**ONE MONUMENT SQUARE
 ENTRANCE AND LOBBY RENOVATIONS
 FINARD & COMPANY
 PORTLAND, MAINE**

TITLE
SITE LAYOUT
PLAN

C1

SCALE
AS NOTED

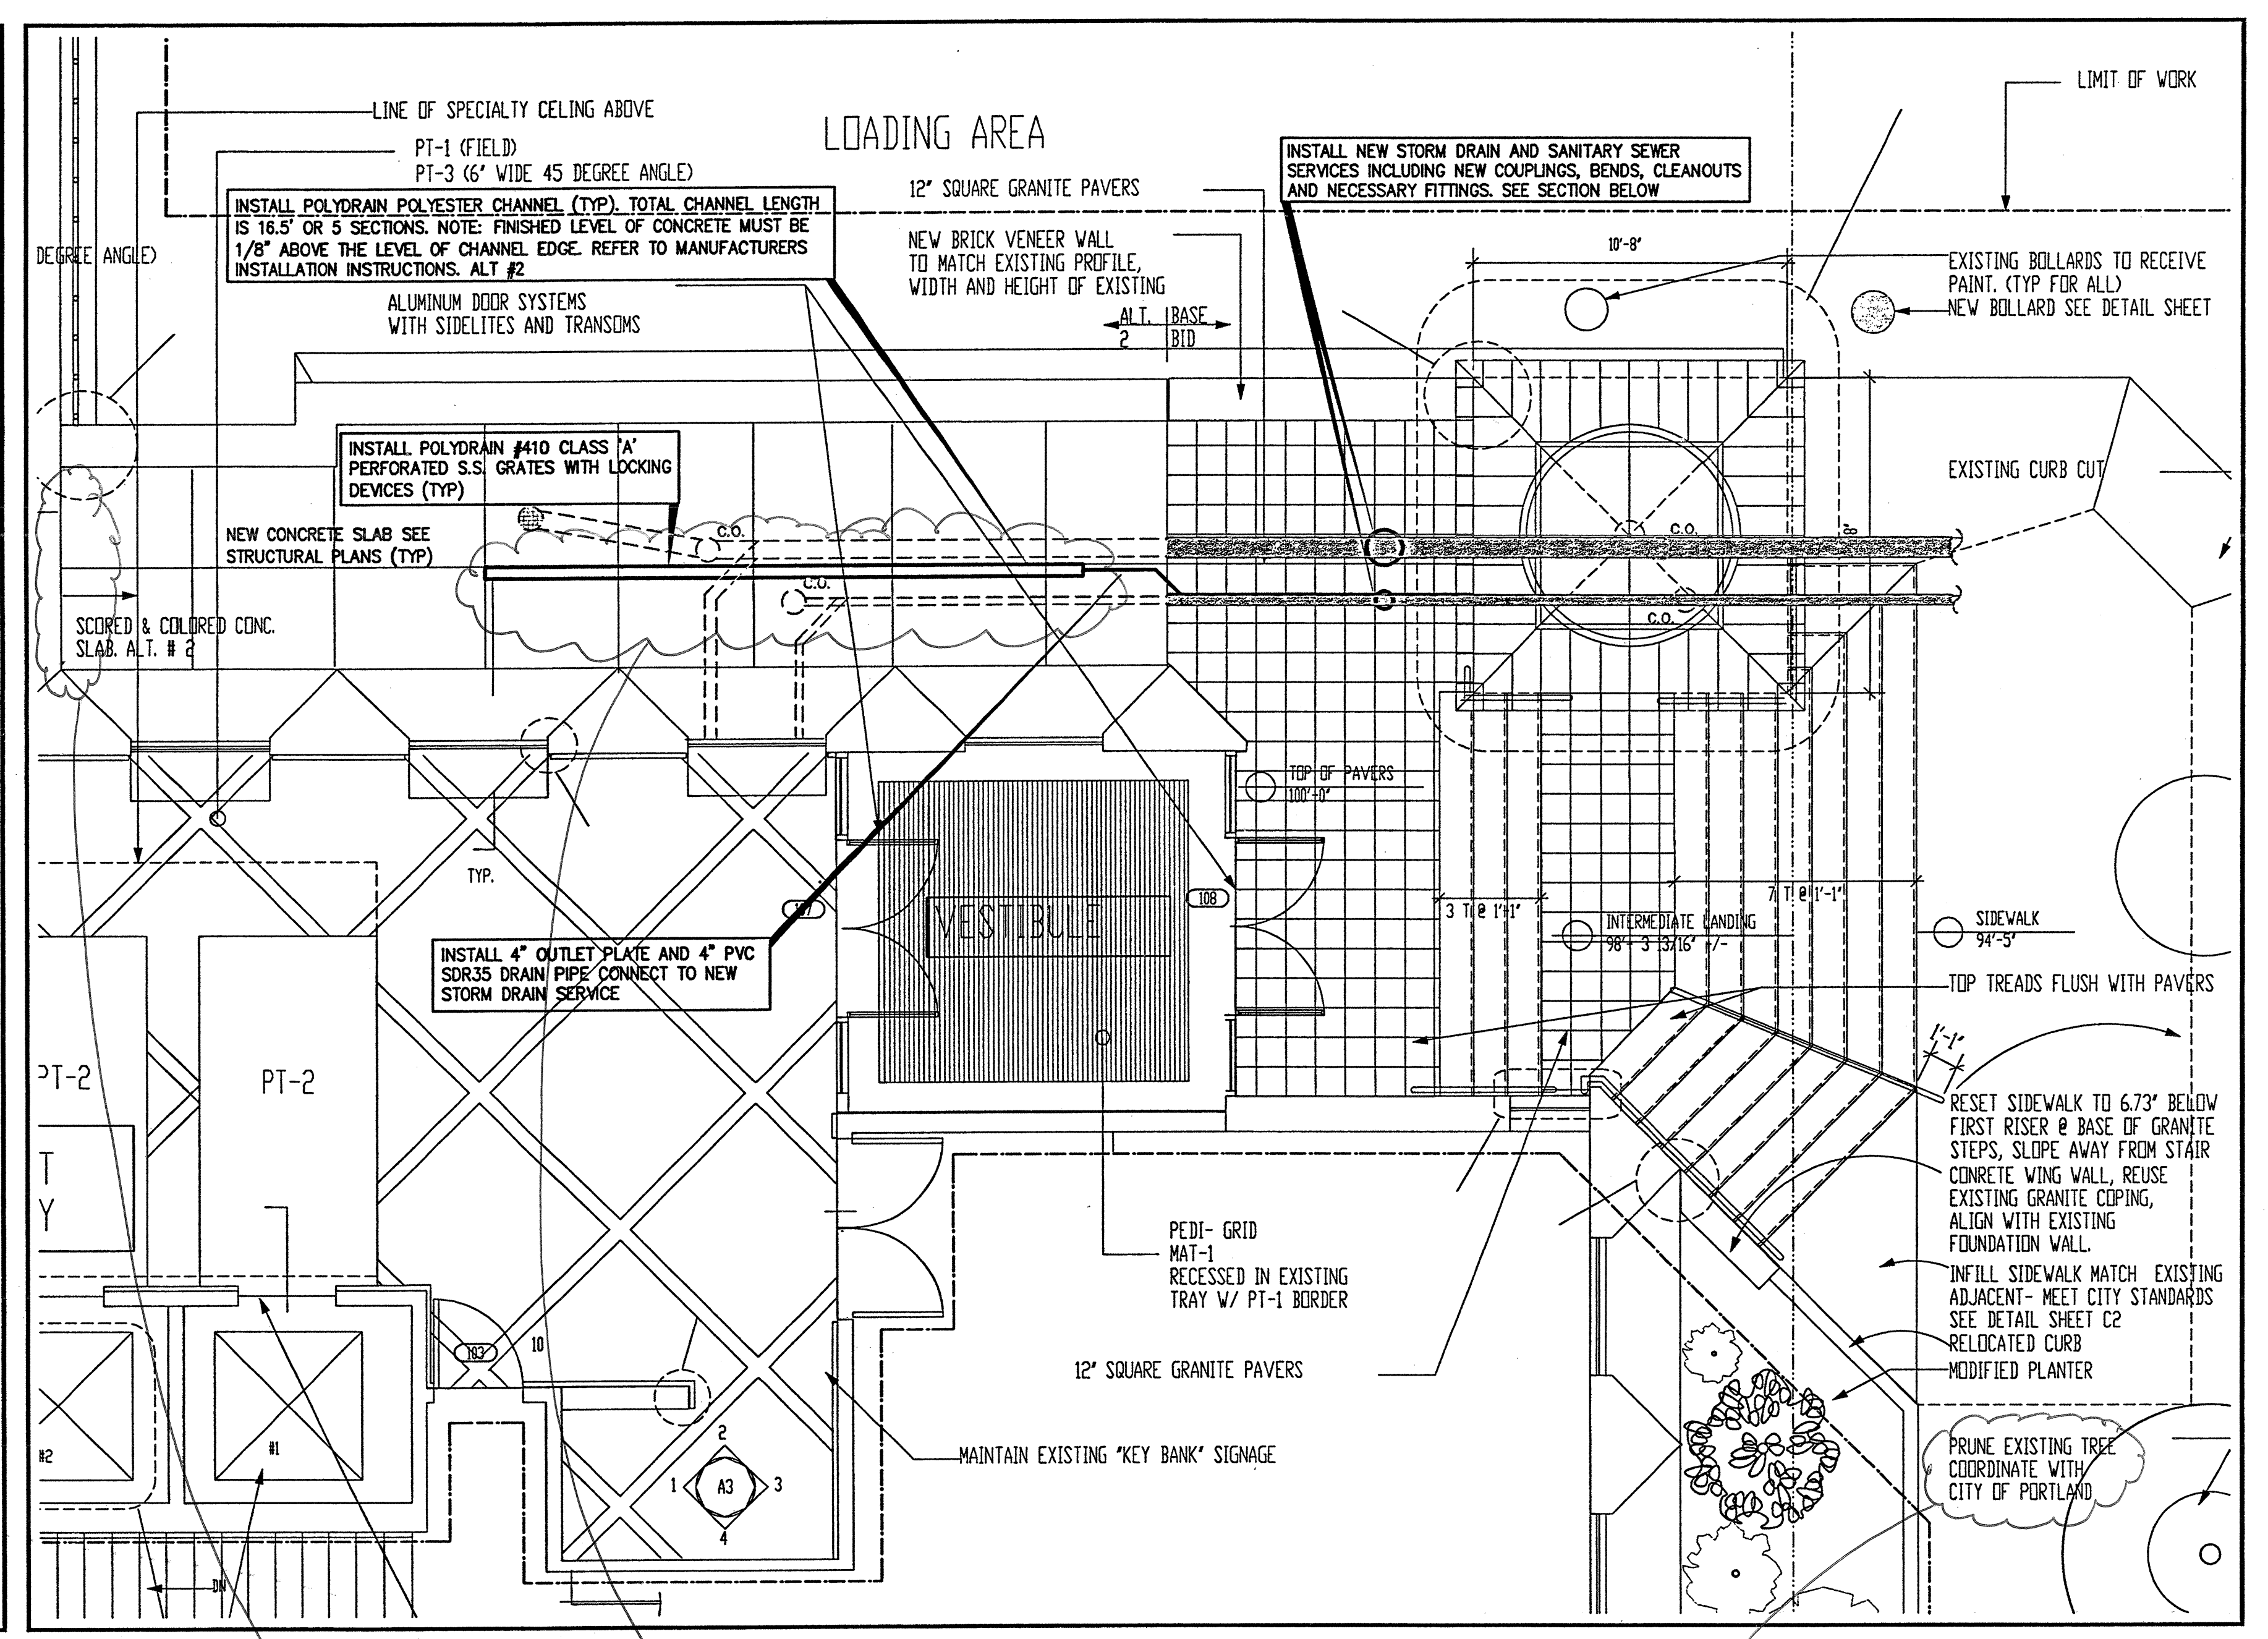
Ⓢ Teach drain line this not as Plan view A-1
 Ⓢ [Low Point] Section of Poly drain correct drain location at A4#2 wall see site conditions
 Ⓢ Call Alford ax said he could do the work, but never seen them come to site

Ⓢ These floor drains not this way (not tied to storm drain) they are tied together and exit at driveway side of Monument. See site conditions.

Ⓢ Elenton way see site conditions
